**Cards and security devices for
personal identification — Contactless
proximity objects —**

**Part 3:
Initialization and anticollision**

**AMENDMENT 2: Enhancements for
harmonization**

Page 17, Figure 9

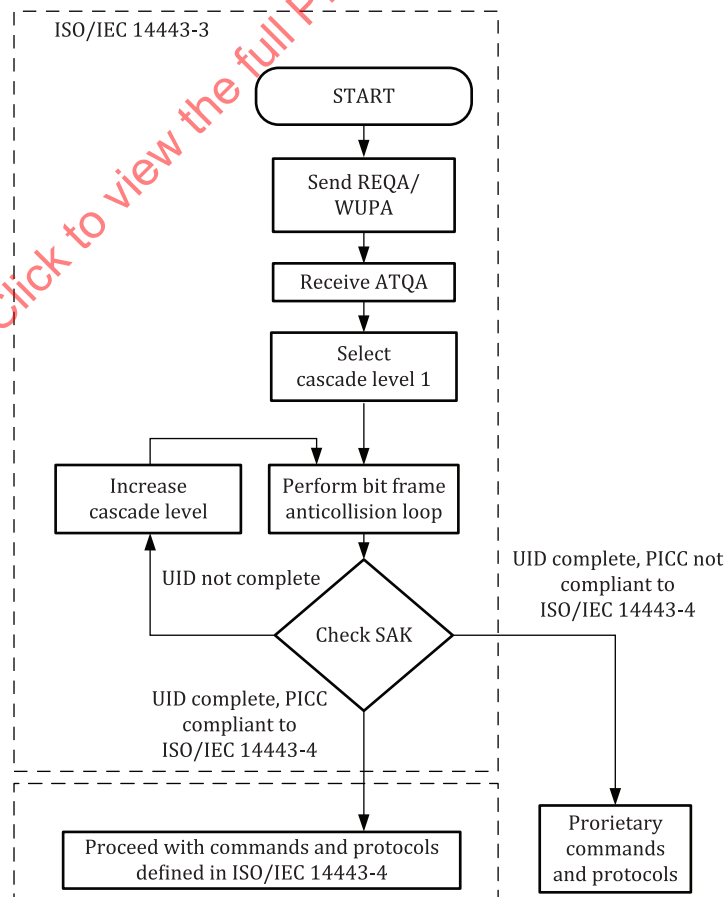
Replace "REQA" by "REQA/WUPA"; i.e. replace Figure 9 with the following figure:
